# UNITED STATES PATENT AND TRADEMARK OFFICE

APPLICATION NO.	FILING DATE	FIRST NAMED INVENTOR	ATTORNEY DOCKET NO.	CONFIRMATION NO.
10/695,849	10/29/2003	Jerome David	SPINE 3.0-414	7827

<b>Office Action Summary</b>	<b>Application No.</b> 10/695,849	<b>Applicant(s)</b> DAVID, JEROME	
	<b>Examiner</b> James L. Swiger	<b>Art Unit</b> 3733

## DETAILED ACTION

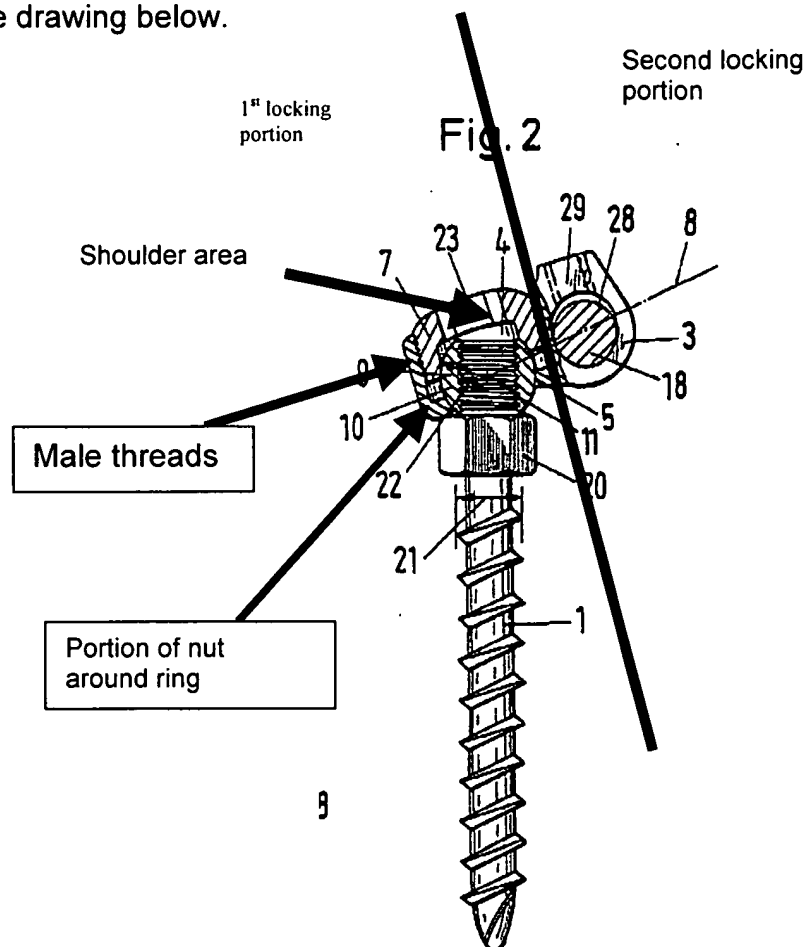
Claims 1-5, 7-16, 19-31, and 39-42 are rejected under 35 U.S.C. 102(b) as being anticipated by Studer et al. (US 6,146,383). Studer et al. discloses a bone fixation assembly comprising what is considered a unitary coupling element (see element in Fig. 2) that permits axial and sliding movement (9) of the coupling element (1) relative to the fixation element (Figs. 1 vs. 2), and that is also adapted to receive a spinal rod (18). The bone fixation assembly also has a first locking element to secure the head portion in the

first bore and a second locking element adapted to secure the spinal rod in the second bore. See drawing below.

The coupling element also comprises a locking nut (7) in the first portion, and where the first locking element comprises a ball ring (9). The second bore via the spinal rod would therefore also have an axis that is transverse to the first bore, extending coplanar in the transverse direction. Further, once the second locking element (through bore 29, and would be considered as a set screw (24)) is set into the device, it is capable of being permanent if the user chooses it to be, and would be fully secure in the connection and stabilizing the spinal rod in place. The device further comprises male

threads in the first bore (see drawing above) and wherein at least a portion of the locking nut surrounds the ball ring. The male threads would inherently fit into the female threads provided on the side of the first bore. The ball ring (9) is also in contact with the coupling member portion (5) at the bottom end of the ring, and the locking nut (7) at the top. The second locking assembly also comprises a set screw (24) that is capable of being seated in the locking member if the user wishes it to be. Also, the bottom portion of the ball ring (9) is tapered (see bottom portion of the first locking element in drawing above) to allow polyaxial motion. The fixation element also has a head portion (proximate to 22) that fits into the first locking element. Further, the ball ring and the locking nut associate with each other and with the head portion of the fixation element that is capable of exerting a radial force onto that element to secure the head of the screw in the coupling element. The set screw (24) or locking nut (7) may provide this means for providing radial forces.

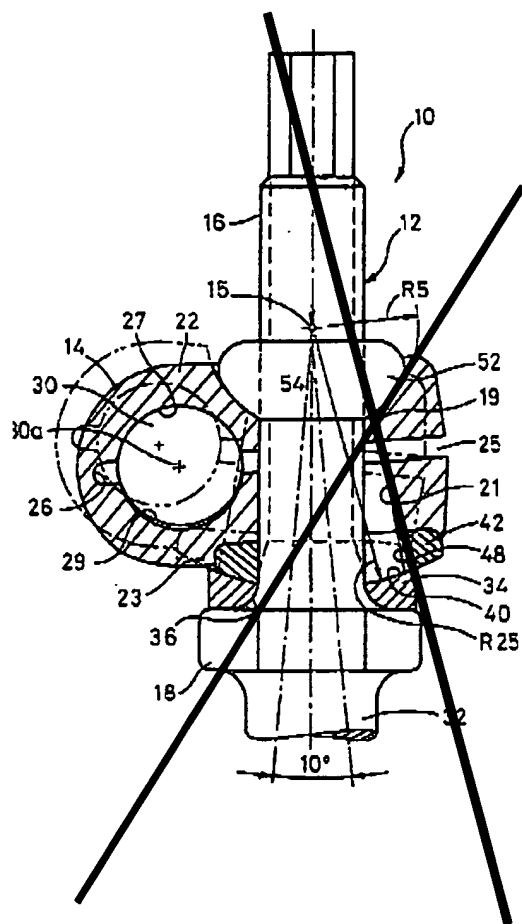
Claims 17-18 are rejected under 35 U.S.C. 103(a) as being unpatentable over Studer et al. '383 in view of Lange (US6,123,706). Studer et al. disclose the claimed invention except for a taper in the locking nut extending in opposite directions from that

of the bore. Lange discloses a taper that is considered to go in opposing directions from the bore and to the locking nut area. See drawing below.

The lines above represent the two tapers: one from the locking nut area (upper portion) and one from the bore (lower portion). These tapers provide a means for the spinal screws to be readily adjusted when they are in use. (See Col. 1, lines 35-67). It would have been obvious to one having ordinary skill in the art at the time the invention was made to construct the bone fixation device of Studer et al. having at least opposing tapers in view of Lange to better allow the spinal fixation element to be adjusted in use.

**FIG. 4A**

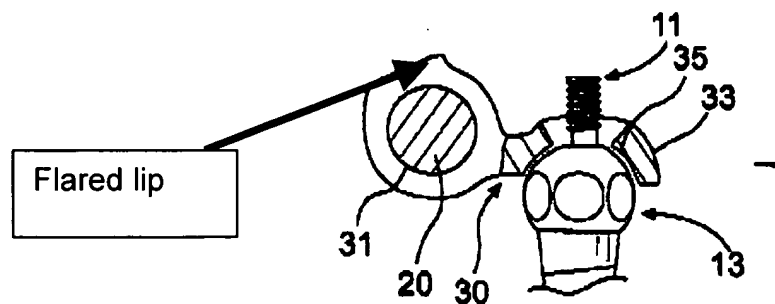
Claim 6 is rejected under 35 U.S.C. 103(a) as being unpatentable over Studer et al. '383 in view of Gu et al. (US 6,280,443). Studer et al. disclose the claimed invention except for a flared lip that cooperates with the coupling element. Gu et al discloses a taper (see drawing below) that allows for the set member bore (32) to better secure to the rod (Col. 4, lines 42-58).

It would have been obvious to one having ordinary skill in the art at the time the invention was made to construct the spinal fixation device of Studer et al. having at least a flared lip in view of Gu et al. to better secure the locking element and the rod in place and prevent the locking element from becoming removed.
